Proposed solar salt project at Onslow

Gulf Holdings Pty Ltd

**Report and recommendations of the
Environmental Protection Authority**

**Environmental Protection Authority
Bulletin 495
January 1991**

Figure 2: Location of facilities

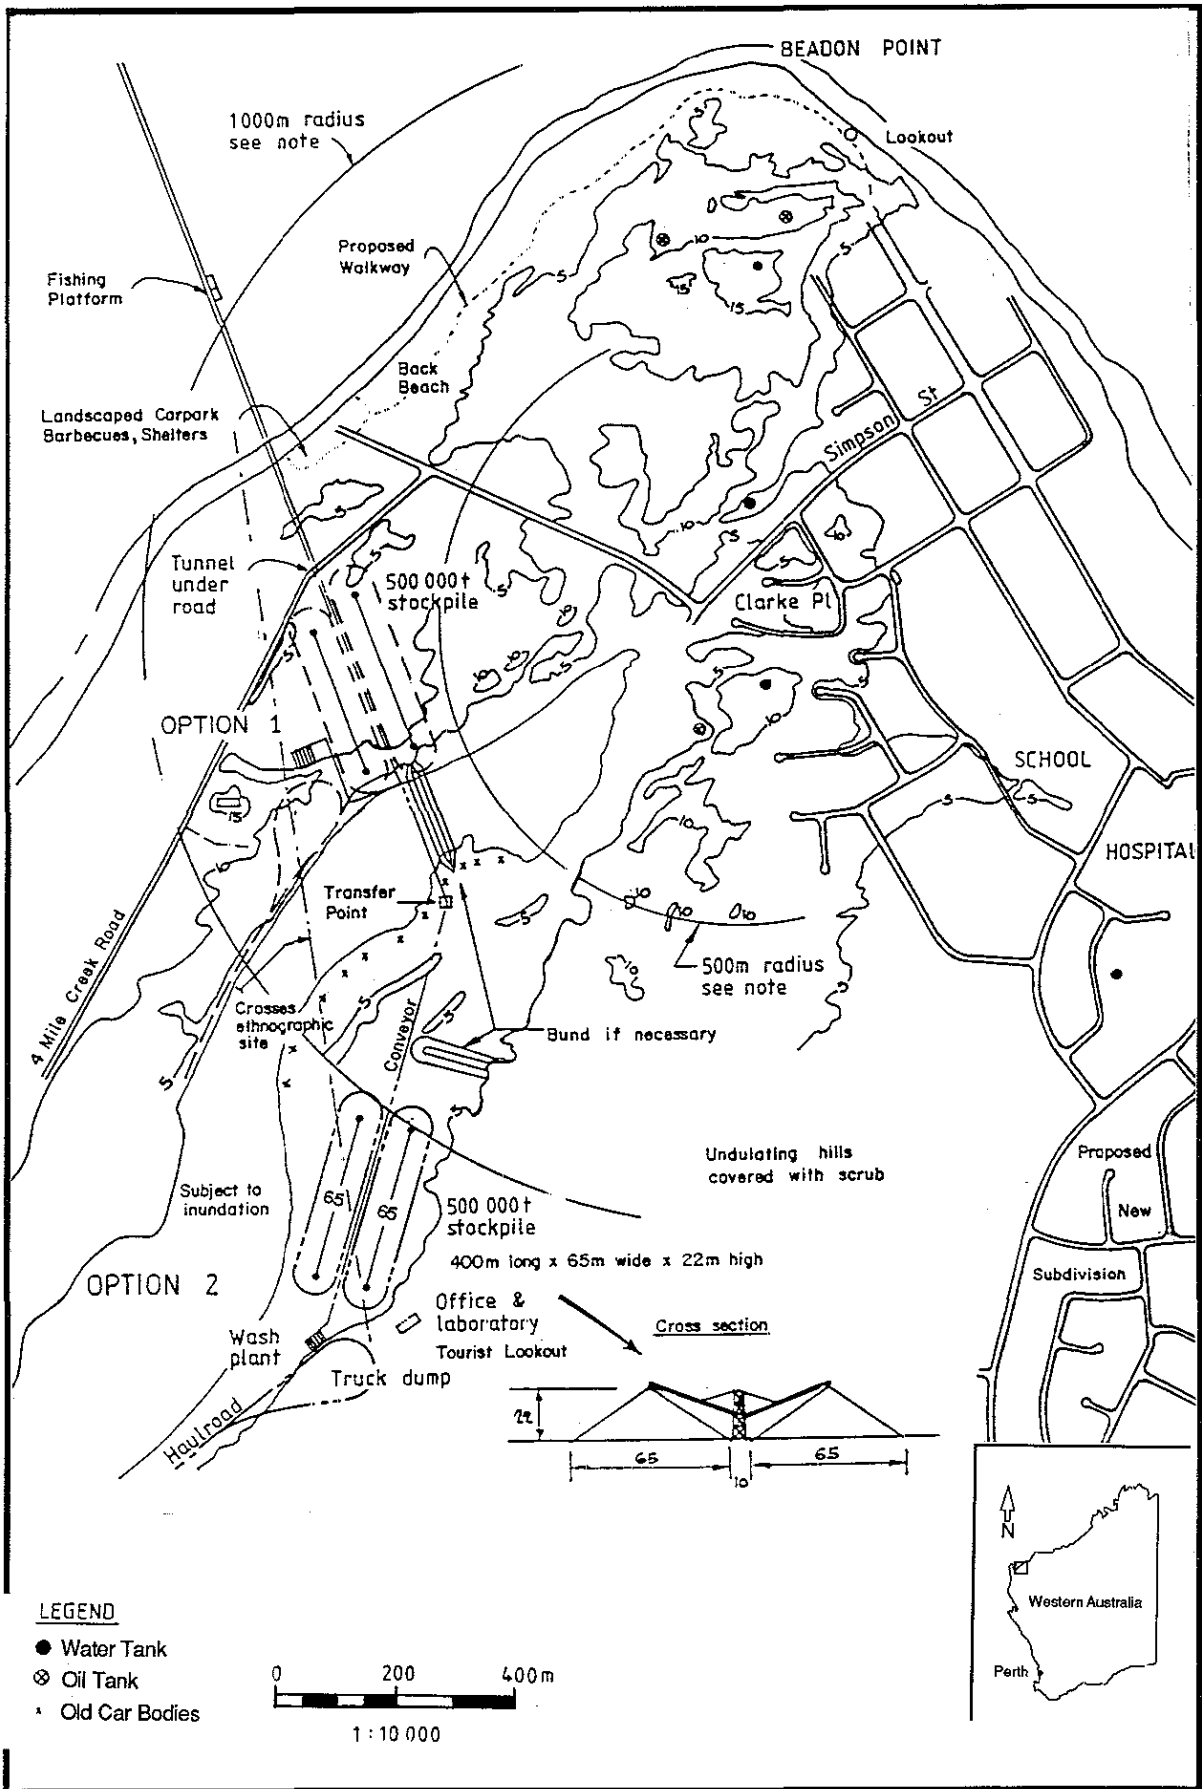
This led to a proposal from Onslow's residents that the processing facilities be relocated. Gulf undertook to shift the plant, resulting in the change from Option 1 to Option 2, as shown on Fig 2. This move has increased the separation to a minimum of 700m from the nearest settled areas (Hooley St) and about 900m from the end of Clarke Place.

FIG. 2

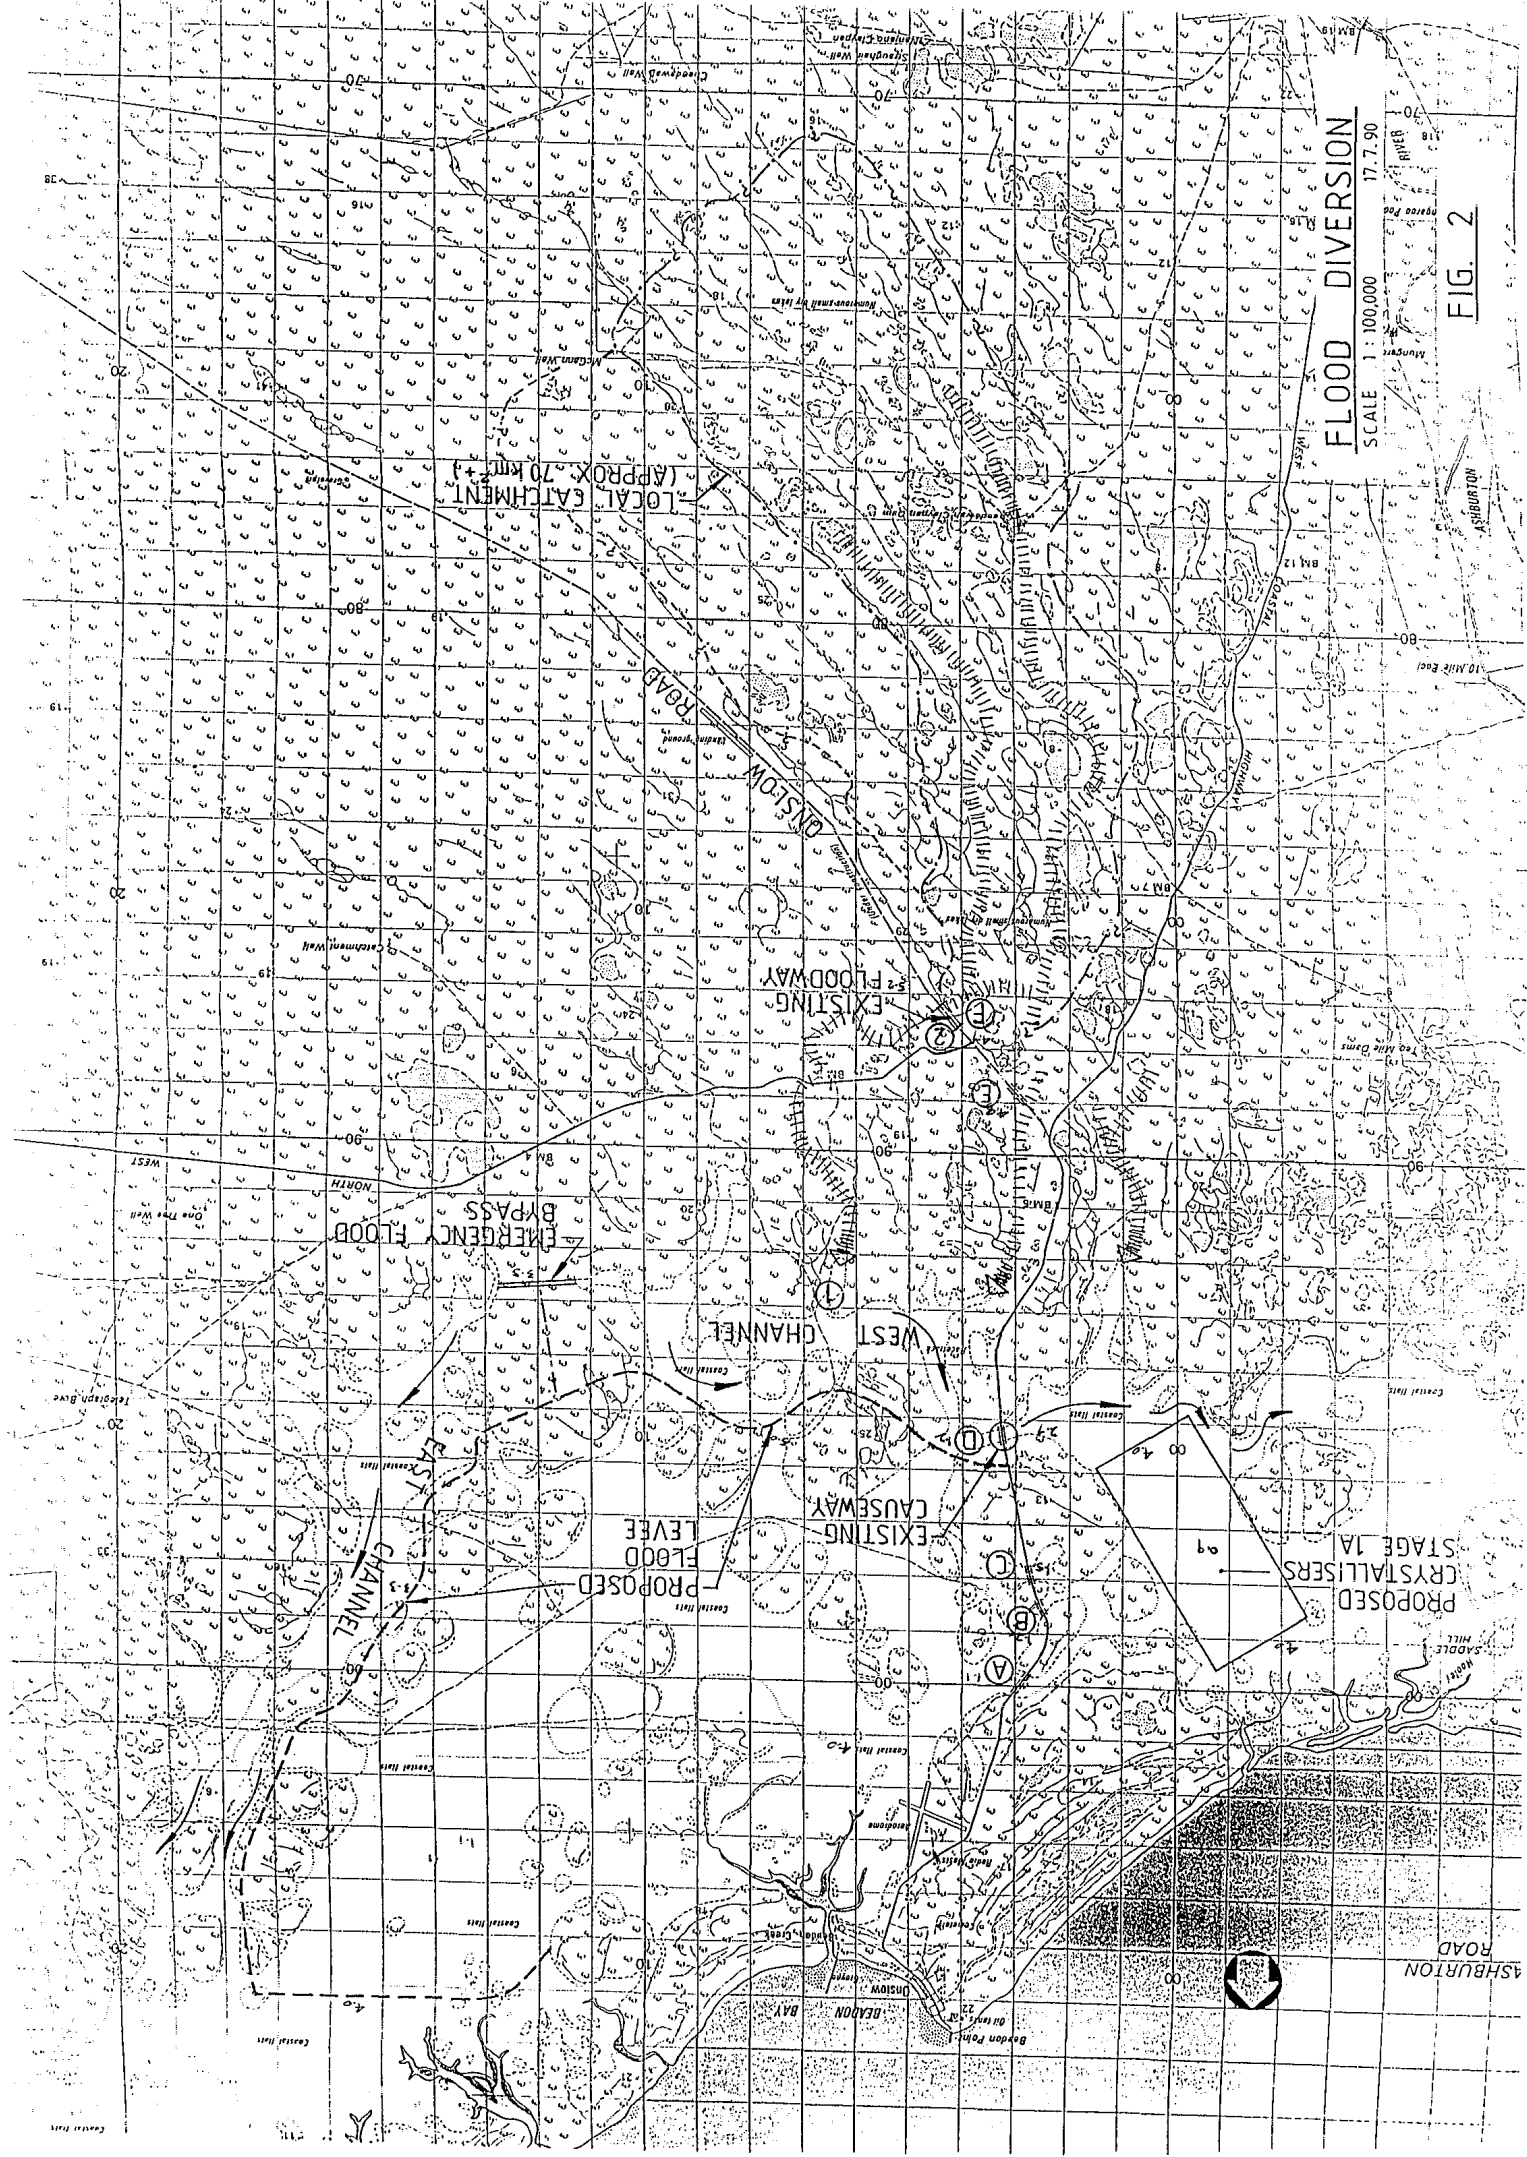
In addition the proponent has proposed a contingency plan to enable exceptionally heavy flows to escape to the east, by creating an emergency flood bypass across low lying land some 8km to the east of the main road (see Fig 1). This would consist of a channel about 100m wide linking tidal flats and enabling excess water to be diverted to the northeast.

A contingency plan could be considered by cutting a saddle bypass at the base of the highland divide where shown on the drawing (1.5 km long x 100 m wide @ AHD +3.5 m).

DRAWING No. **40-10-001**
M8701/001
 SCALE: 1:500
 DATE: _____
 REV: **A**

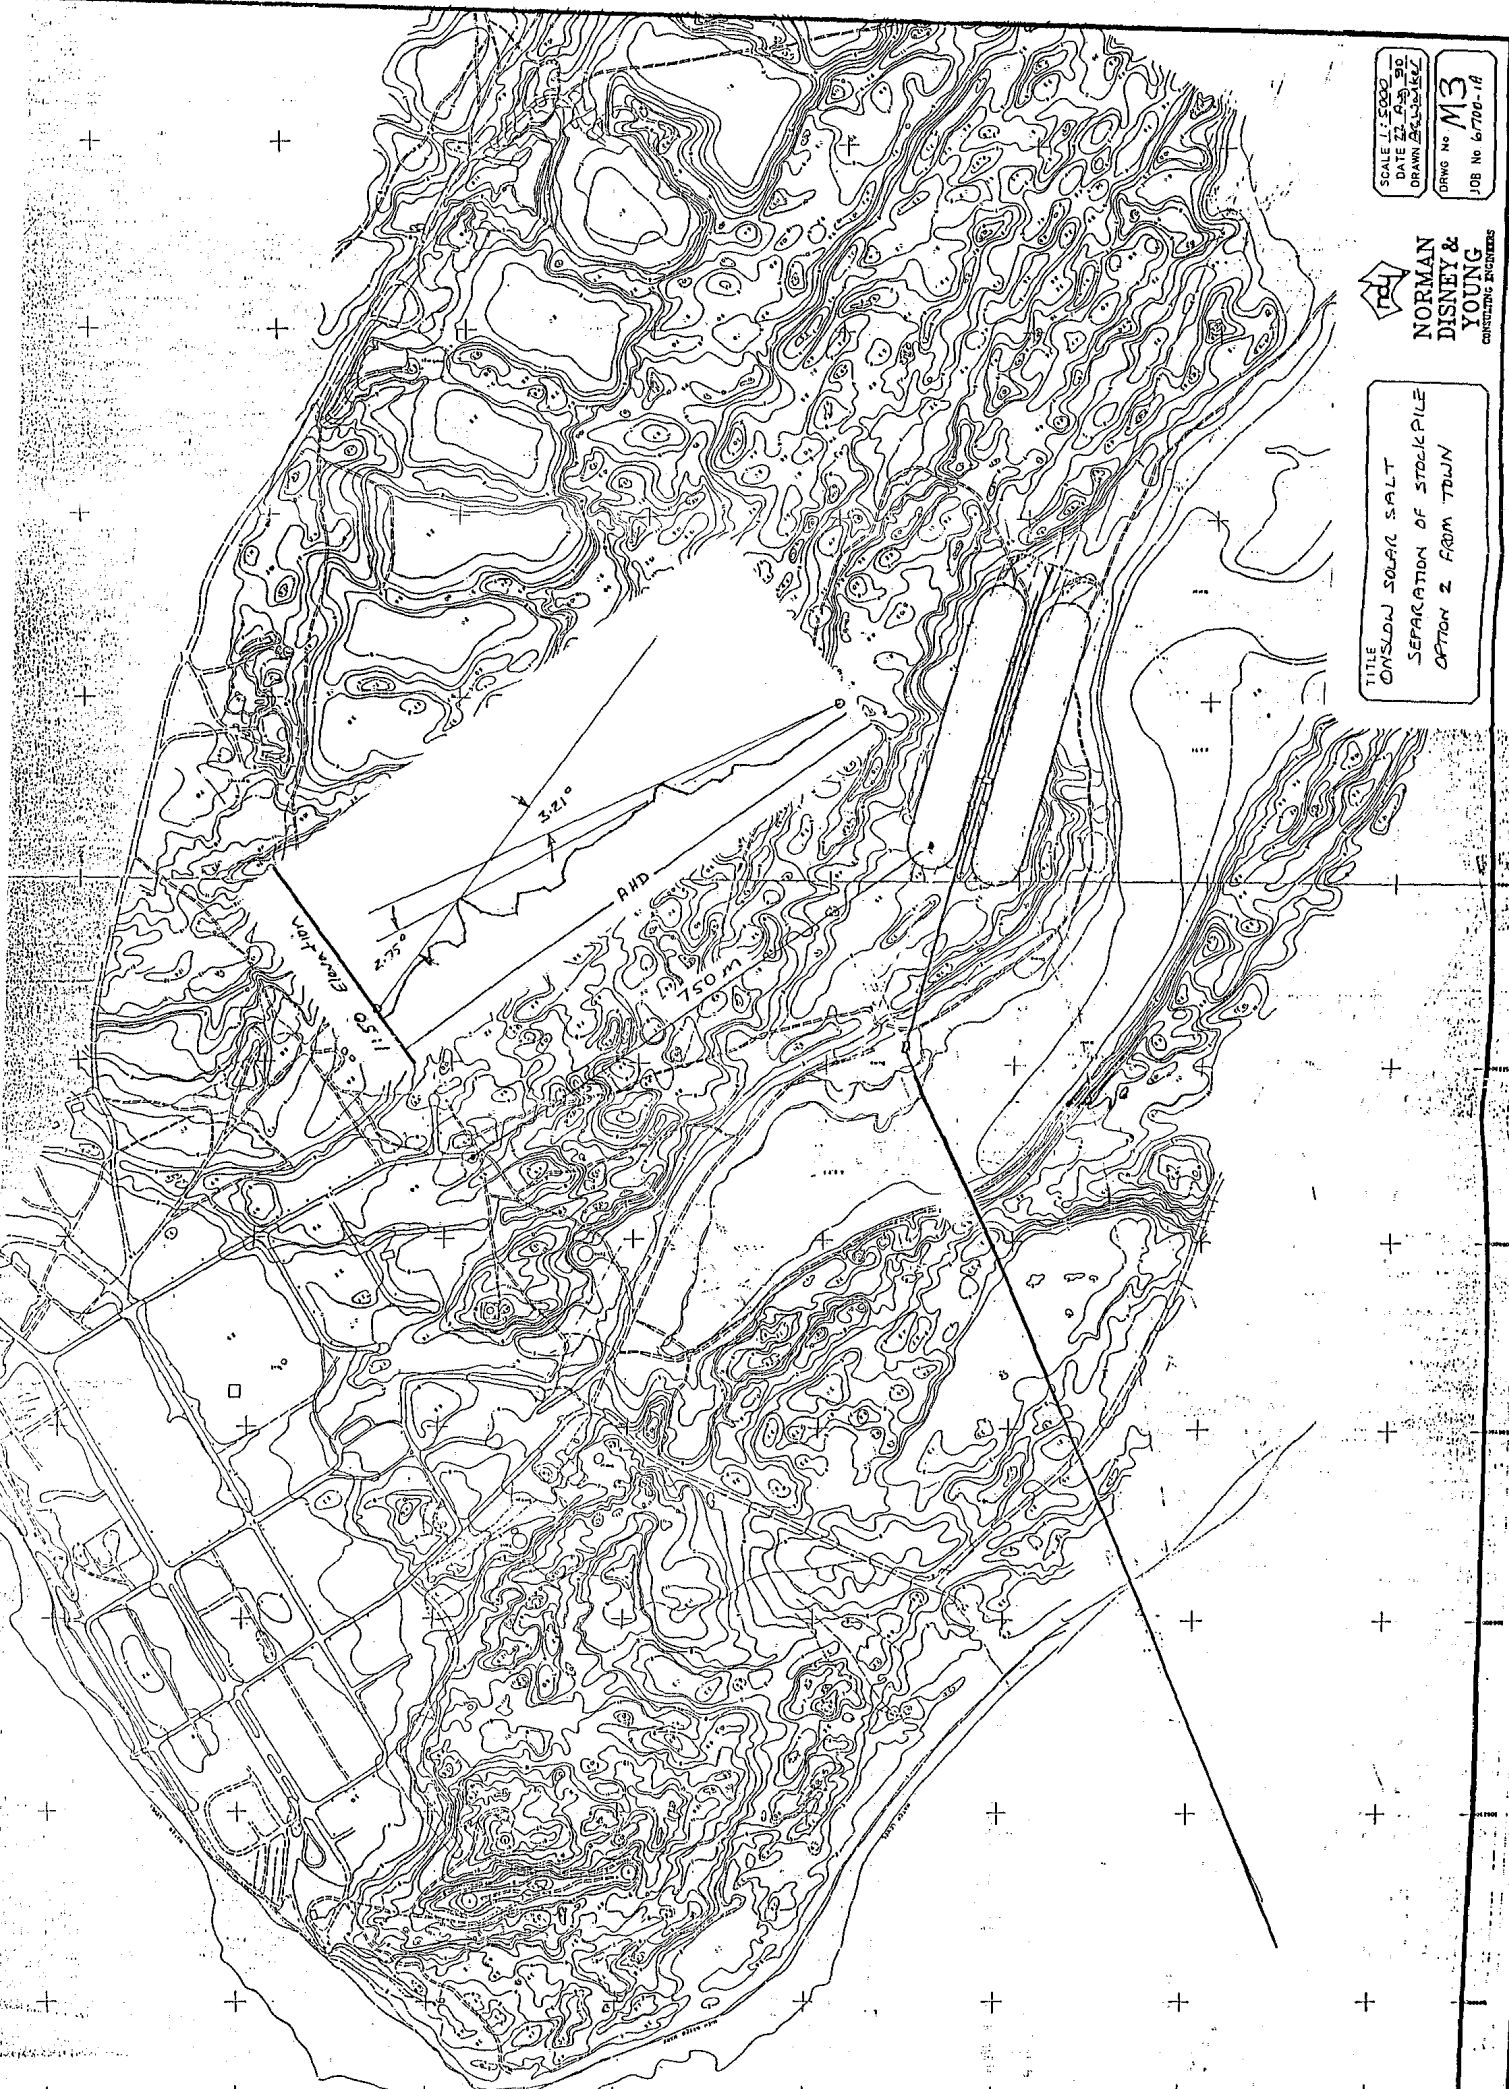
- 4.4.1.5 The ERMP is inaccurate when it describes Site Option 2 as being 1 km further from town - it is only 500 m on Figure 7.

Figure 7 in the ERMP Volume I shows exactly where the stockpile is proposed in relation to the town, landforms and topography. A further larger scale drawing No. 40-10-001 (M8701/001) is enclosed for your information.

Figure 7 in the ERMP showed all of these figures to scale. The attached plan entitled Mechanical Plant - Plan General Arrangement No. 40-10-001; M8701/001 shows in more detail the location of the washplant and stockpile, relative to the town to scale.
